DESCRIPTION Expansion Dam Detail
PROJECT Sandy River Bridge Proj. No. BH-025-2(46)
LOCATION New Sharon, Me.
DESIGNER Me. D.O.T.
CUSTOMER Callahan Bros., Inc.
JOB NO. 89-670-4
DWG. NO. 22
REV. ②

STATE OF MAINE
DEPARTMENT OF TRANSPORTATION
☒ Approved ☐ Returned for Corrections
AUG 16 1989
☐ Approved as noted ☐ Rejected
K. Jacobs
WELDING ENGR.

DESCRIPTION SPLICE PLTS FOR LINK RETROFIT
PROJECT SANDY RIVER BRIDGE PROJ. No. BH-025-4(26)
LOCATION NEW SHARON, ME
DESIGNER ME DOT
CUSTOMER CALLAHAN BROS.
JOB NO. 89-670-2   DWG. NO. 1   REV. (A)

DESCRIPTION EXPANSION PEDESTALS @ PIER #3
PROJECT SANDY RIVER BRIDGE BH-025-2(46)
LOCATION NEW SHARON, ME.
DESIGNER ME. D.O.T.
CUSTOMER CALLAHAN BROS., INC.

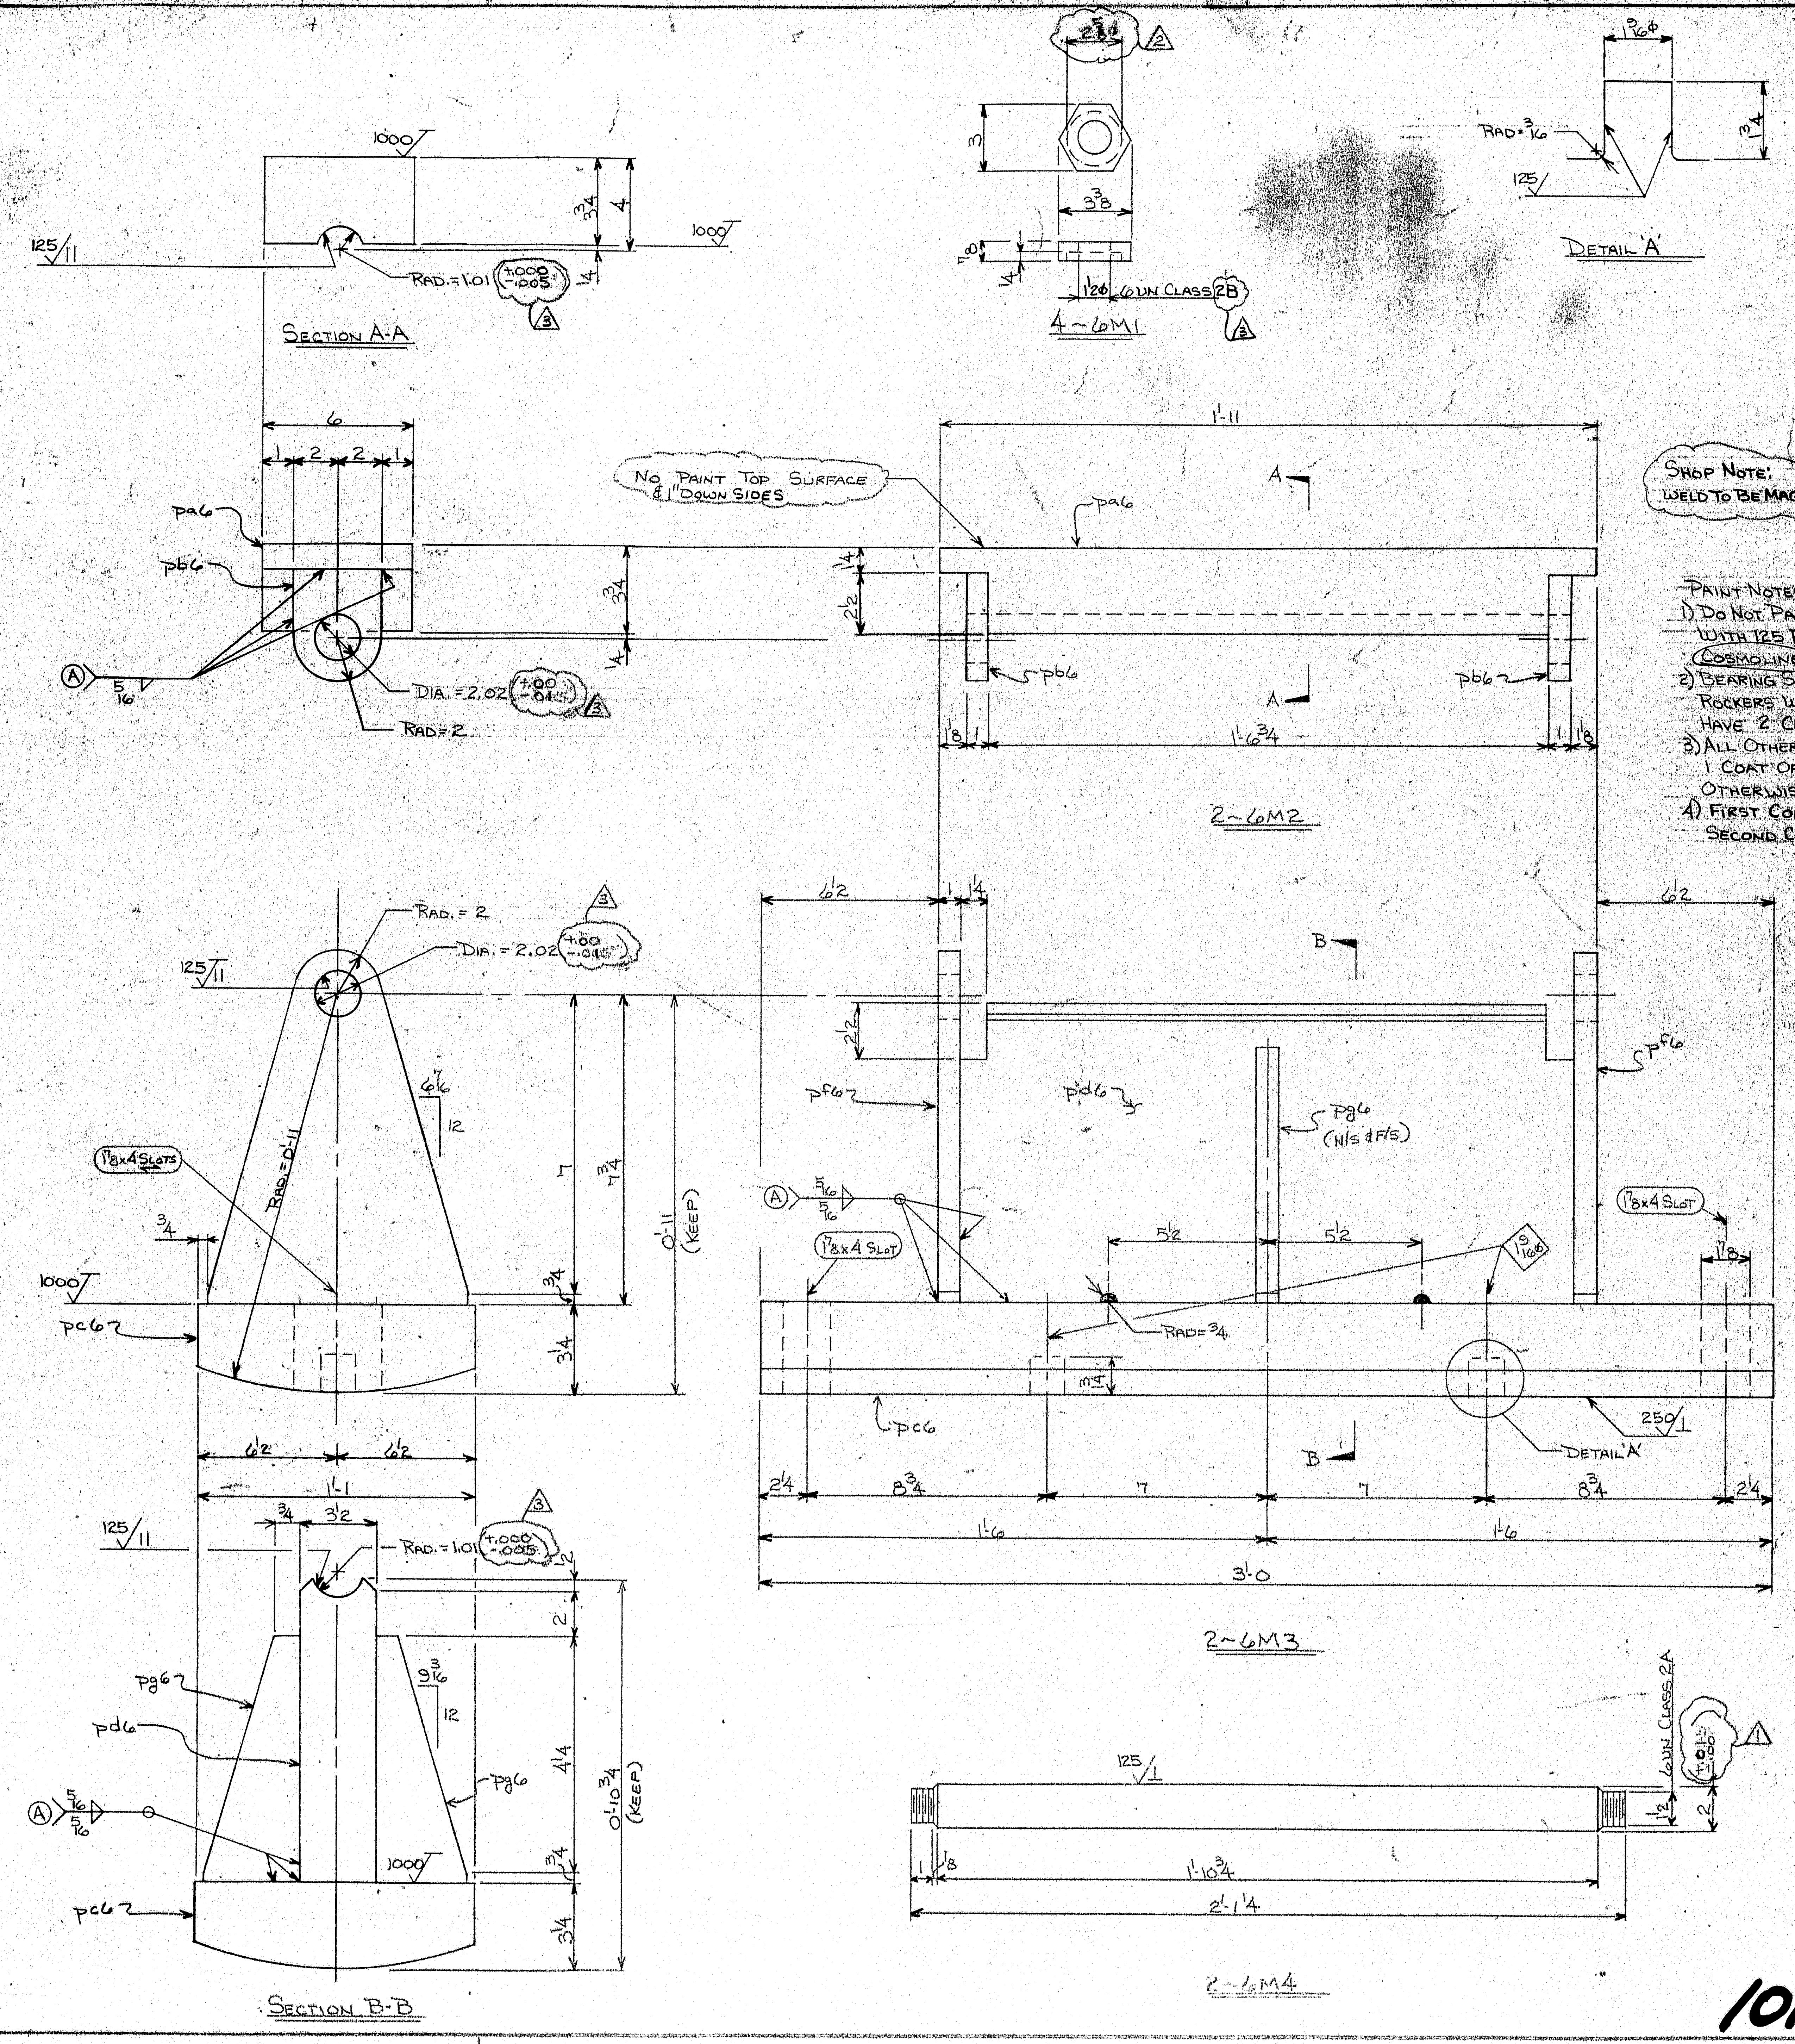
PAINT NOTES:
1) DO NOT PAINT OR BLAST SURFACES WITH 125 FINISH COAT WITH COSMOLINE. specification please !!!
2) BEARING SURFACES OF EXPANSION ROCKERS WITH 250 FINISH TO HAVE 2 COATS OF PAINT.
3) ALL OTHER SURFACES TO HAVE 1 COAT OF PAINT UNLESS NOTED OTHERWISE.
4) FIRST COAT - ORANGE
SECOND COAT - MAROON
